## Determination 2011/019

# Compliance of a proposed safety barrier to a house deck at Rawhiti Road, Little Taupiri Bay

1.3 The matter to be determined<sup>2</sup> is whether the proposed deck barrier (“the proposed barrier”) complies with Clause<sup>3</sup> F4 Safety from Falling of the Building Code (Schedule 1 of the Building Regulations 1992).

**Figure 1: cross section through the barrier (note the wires are shown at 100mm centres, not at 76mm as proposed)**

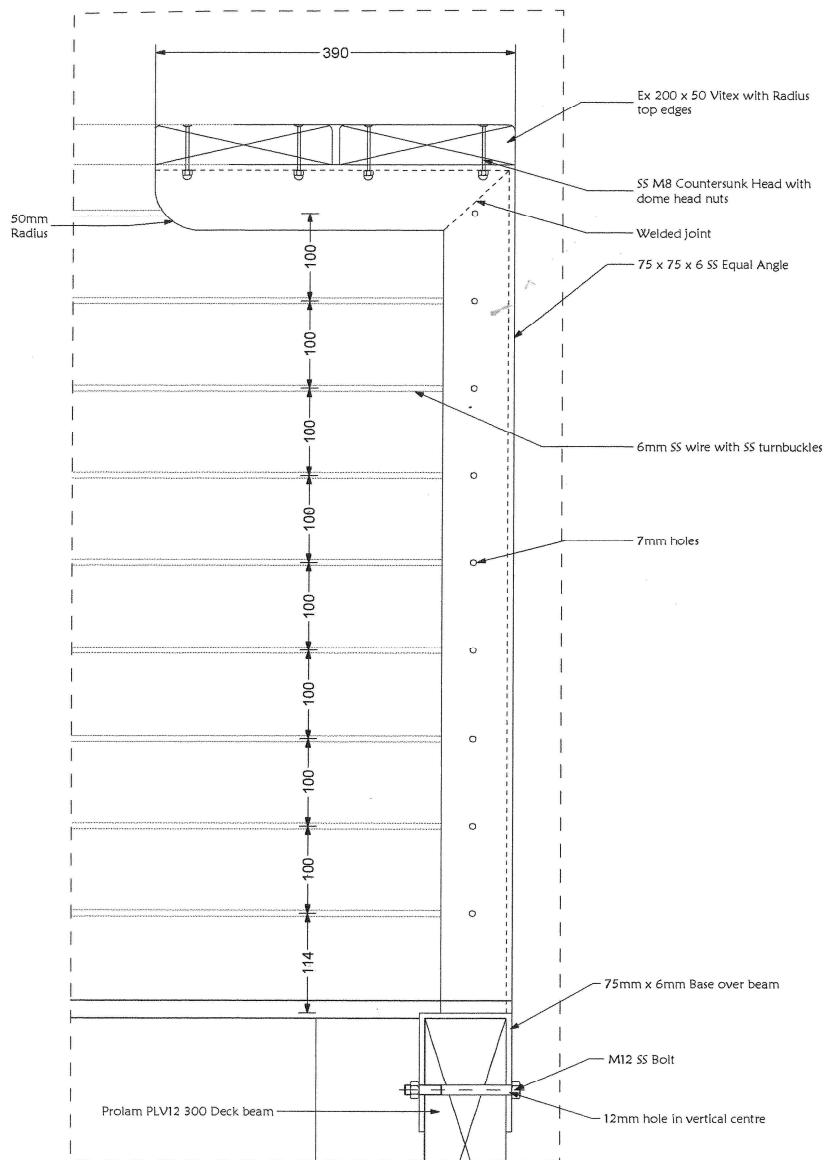
4.2.1 Although I have not been provided with exact measurements for the finished height of the proposed barrier, it appears from the plans that it will be 1000mm. Paragraph 1.1 of F4/AS1 gives minimum heights for barriers; for balconies and decks to dwellings this height is 1000mm. Accordingly, it appears that the finished height of the proposed barrier complies with Clause F4.3.4(b).

4.3.4 The openings in the barrier are formed by the spaces between the horizontal wires. I consider that the spacing at the midpoint of any given span, under pressure, must be no greater than 100mm in order to adequately restrict the passage of children under the age of six.

4.3.6 There is some discrepancy between this assertion, and the proposed barrier design as shown on the plans. The plans currently show the wires 100mm apart.

- 4.3.10 I must therefore consider whether the proposed barrier will restrict children under six years from climbing over it to the same extent as an F4/AS1 barrier would. I consider that horizontal wires would provide toeholds that would make it easier to climb than a F4/AS1 barrier with vertical members. However, the proposed barrier has inward-facing return at the barriers top.

- 4.3.12 However, in this case, I consider the inward return is a satisfactory compensating feature, which would make the proposed barrier as difficult to climb as a barrier described in F4/AS1.

- 4.4.2 A producer statement (PS1), including calculations and engineering details, has been provided for the balustrade posts that says the balustrade will comply with Clause B1 Structure subject to certain conditions. One condition is that the 'minimum beam connected to is 90 wide and beam is secured against twisting'. The plans for the proposed barrier show the timber beam supporting the balustrade posts is shown to be 75mm wide, which is less than the minimum required by engineering details.

- 4.4.3 The engineering details also show the maximum centres for the balustrade posts (1200mm), the weld joint of the post to the bracket (4mm fillet), and bracket fixing to support beam (4xM12 bolts). In my view the proposed plans need to include these details.

- 4.4.4 The barrier needs to be checked to show it is capable of supporting the tensioned wires as the calculations appended to the PS1 do not cover this aspect.

- 4.4.5 The Building Code of Australia<sup>4</sup> contains provisions for the construction of barriers with horizontal wire systems which may be helpful in determining the maximum wire spacing, the required wire tension, and the maximum deflection. In this instance the wire tension is not sufficient if a force of only 20 Newtons (the equivalent of a 2 kilogram mass) is required to create a gap between the wires of 100mm. With the barrier as proposed, 20 Newtons will bring about a wire displacement of about 12mm, but in the Building Code of Australia and for a similar situation, a 20 Newton force is only permitted to cause a displacement of less than 4mm.

- 4.4.7 The tensioning of the wires, the ability of the balustrade posts to support the tensioned wires, and the discrepancies between the engineering details and the plans will need to be resolved before the proposed barrier can be said to comply with Clauses F4.3.4(c) and (d) of the Building Code.

- 4.5.1 The 390mm wide inward return itself provides a platform that, in my view, invites people to get onto and traverse. The desire to do so will be reduced if the elements making up the platform are altered in such a way as to make the ability to sit on or walk along the platform difficult or uncomfortable.
- 4.5.2 I consider the inward return as proposed needs to be modified, for example; by limiting any adjacent elements that can be walked on to an overall width of 150mm, by replacing the timber members with tubular elements or tensioned wires, or by combination of these methods. If tensioned wires are used, a solid member could be positioned along the inner edge of the return.

- 4.6.1 For the reasons set out above, I consider that the proposed barrier, as currently designed, does not comply with Clauses F4.3(c), (d) and (g) of the Building Code.
- 4.6.2 The applicants should address the matters discussed herein and re-apply to the authority for an amendment to the building consent. The authority may agree to the amendment once it is satisfied that compliance will be achieved.
